DRAFT AMENDMENT ISO/IEC DIS 8802-3/Amd.3
IEEE Std 802.3aj-2003

AMENDMENT 3: Maintenance 7

IEEE Std 802.3aj™-2003
(Amendment to IEEE Std 802.3™-2002)

Amendment: Maintenance 7

Figure 13–1—Example of maximum transmission path with five repeater sets enabled by Model 2 Transmission System validation

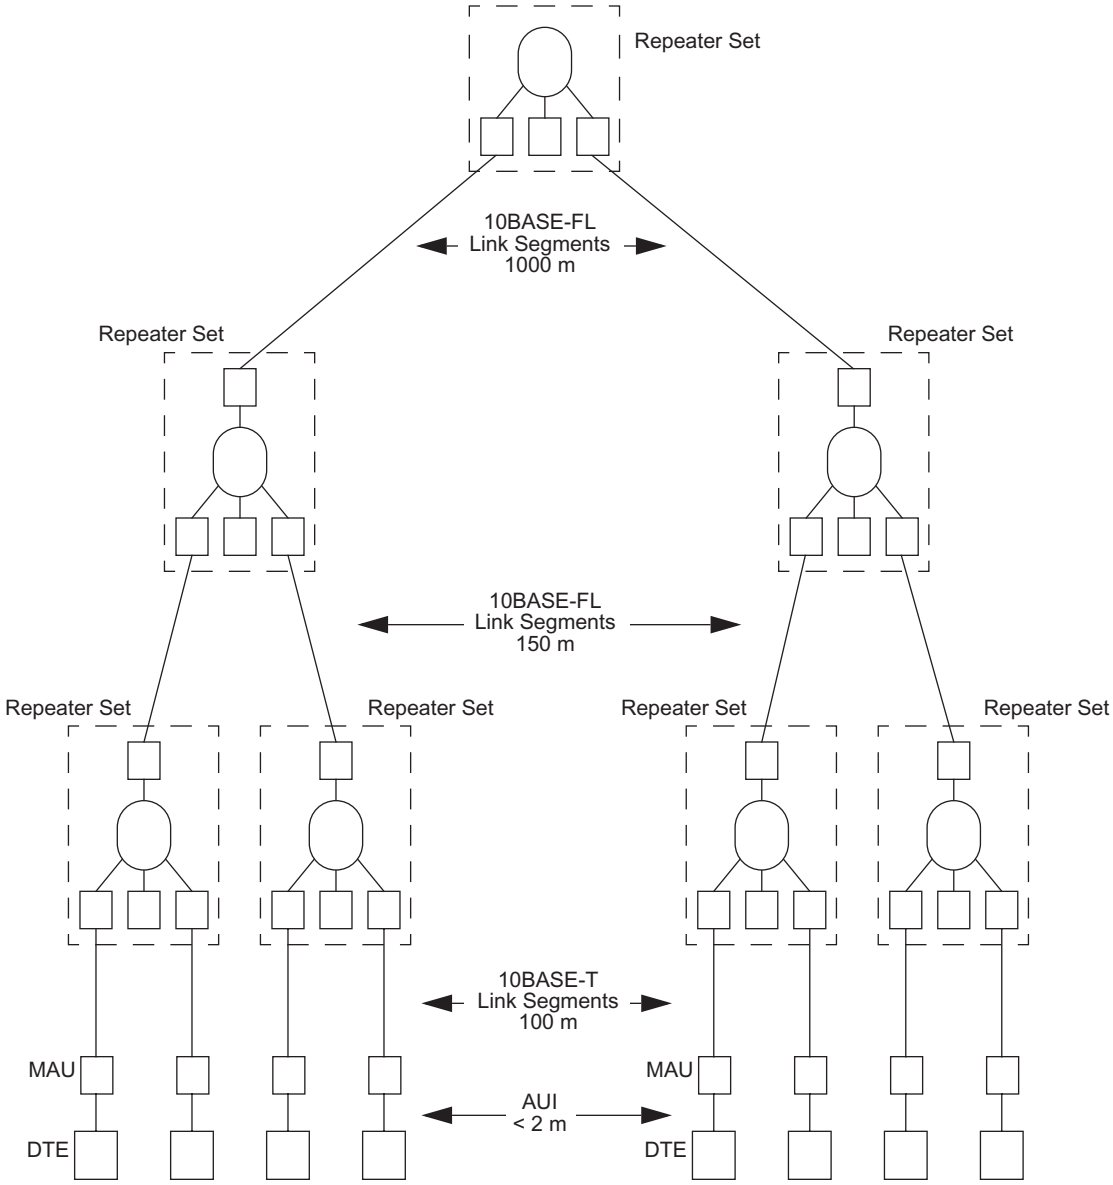
Insert new Figure 13–1 into subclause 13.1 as follows. Renumber all existing Clause 13 figures.

Figure 31–4—Generic MAC Control Receive state diagram

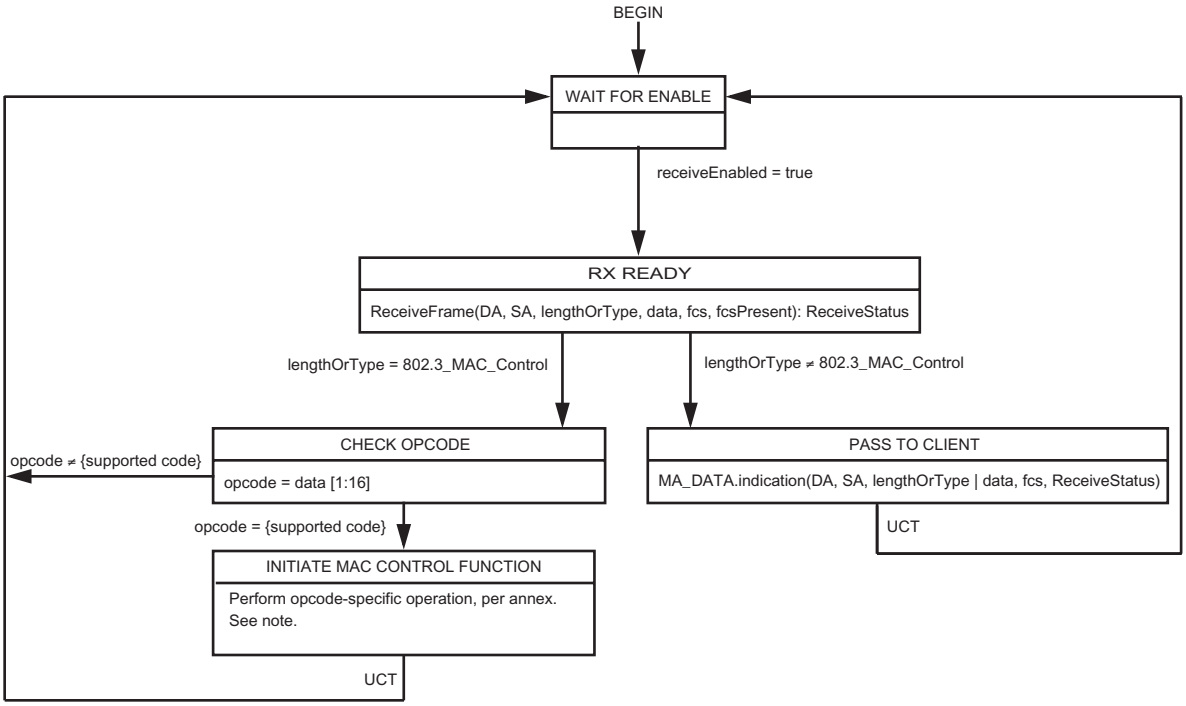
Replace Figure 31–4 with the following:

NOTE—The opcode-specific operation is launched as a parallel process by the MAC Control sublayer, and not as a synchronous function. Progress of the generic MAC Control Receive state machine (as shown in this figure) is not implicitly impeded by the launching of the opcode-specific function.

Figure 43–3—Frame Collector state diagram

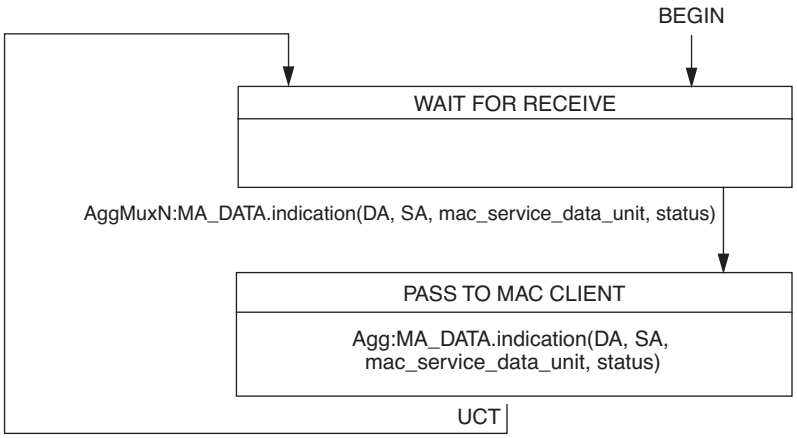
Replace Figure 43–3 with the following:

Figure 43–4—Frame Distributor state diagram

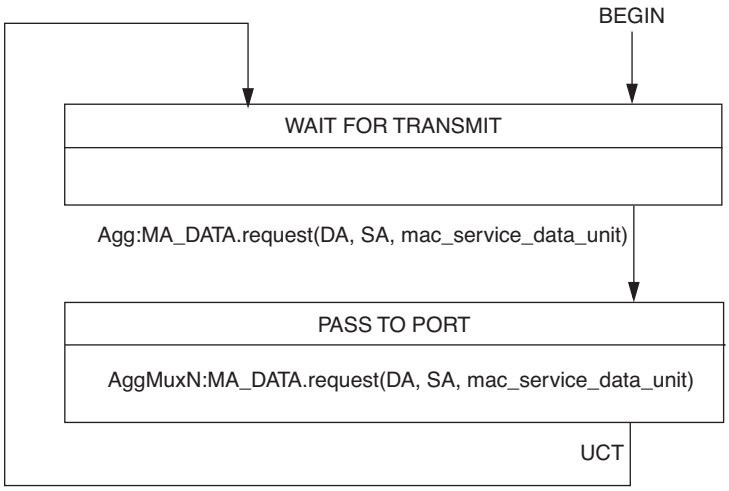
Replace Figure 43–4 with the following:

Figure 43–5—Aggregator Parser state diagram

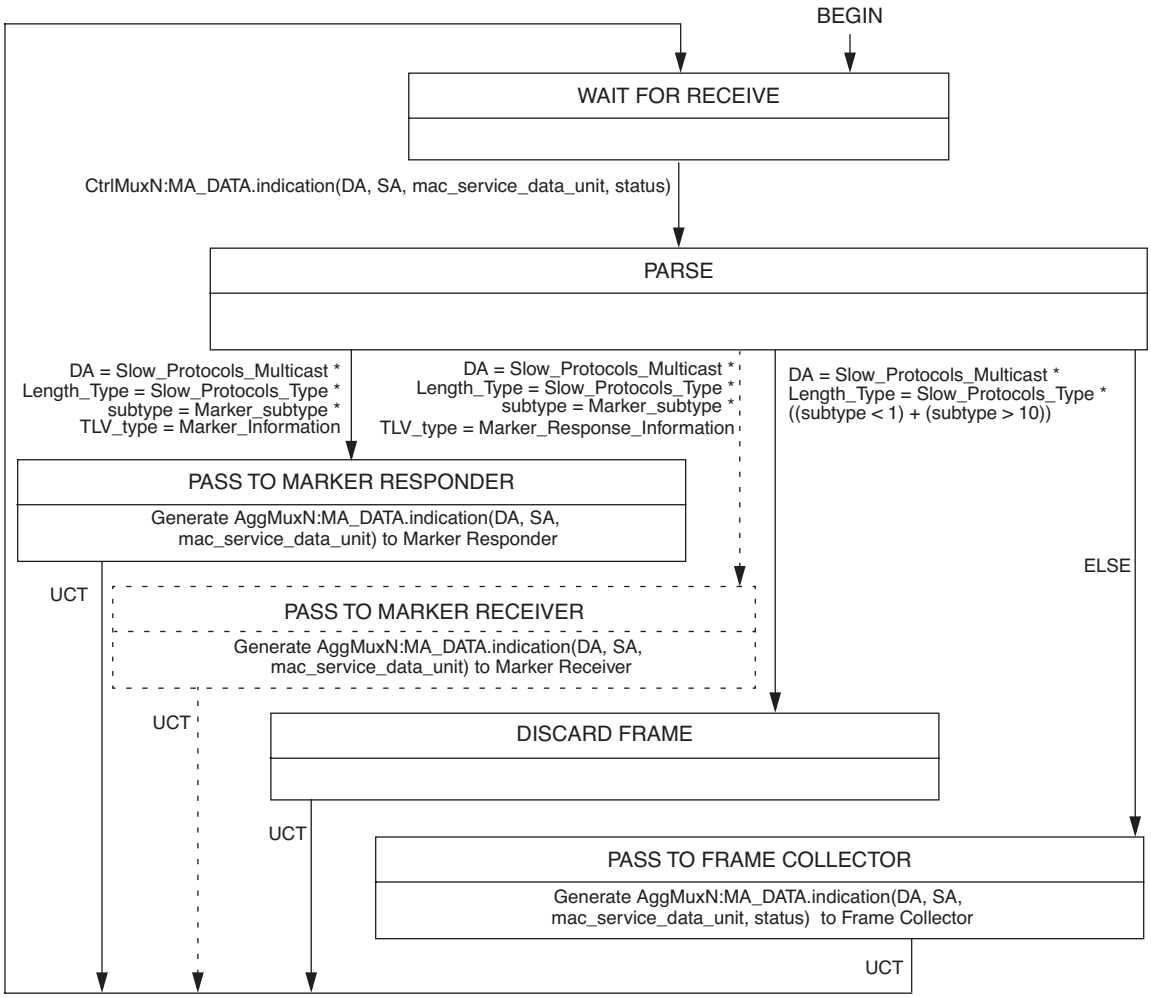
Replace Figure 43–5 with the following:

Figure 43–6—Control Parser state diagram

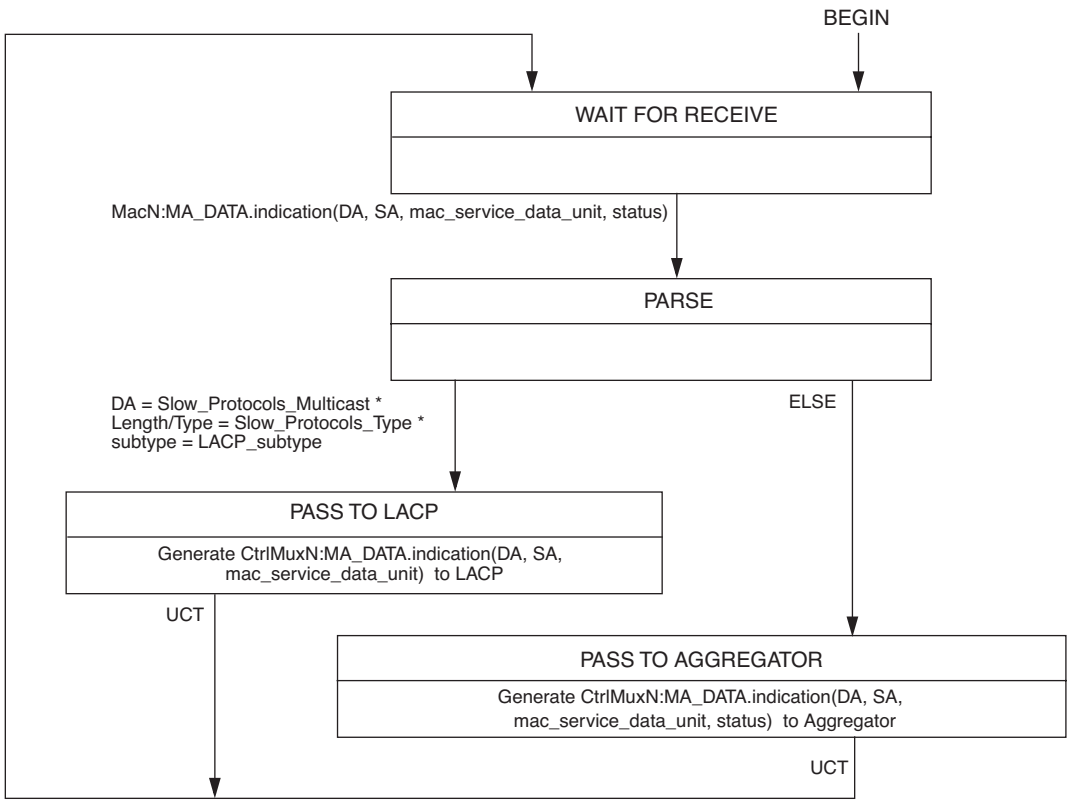
Replace Figure 43–6 with the following:

Figure 43–19—Marker Responder state diagram

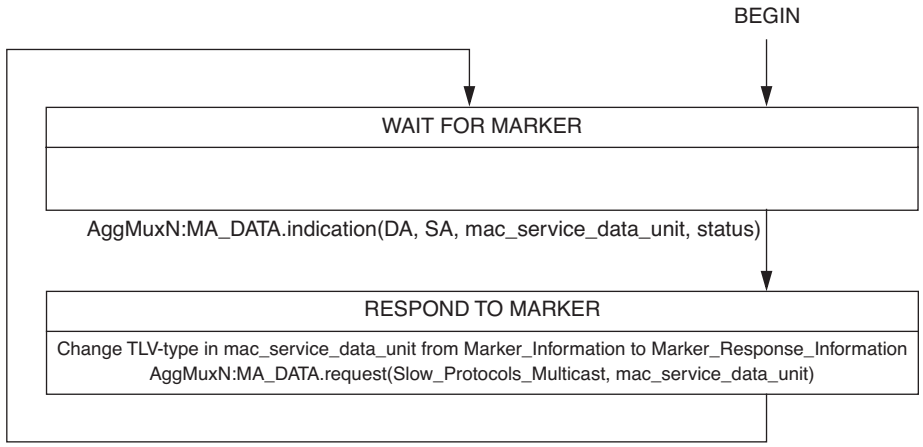
Replace Figure 43–19 with the following:

Figure 31B–2—PAUSE Operation Receive state diagram

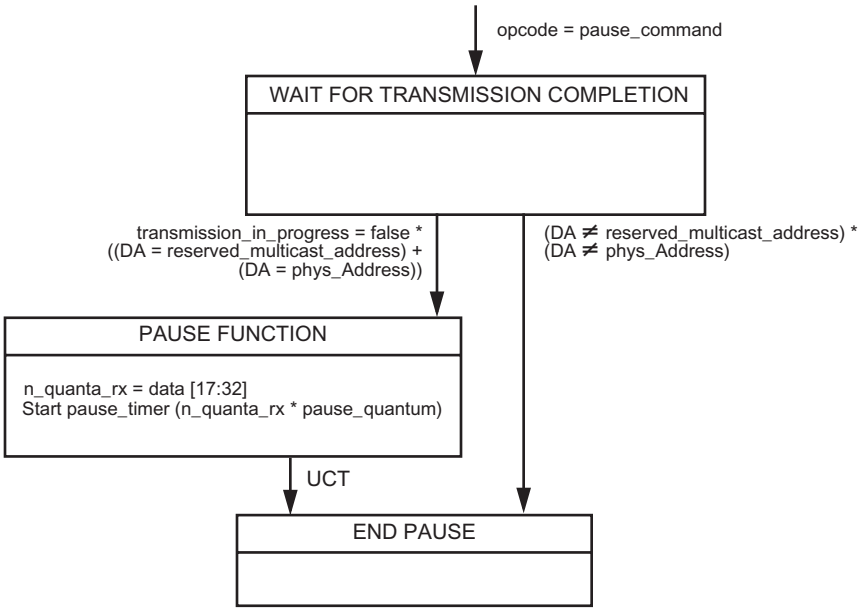
Replace Figure 31B-2 with the following:
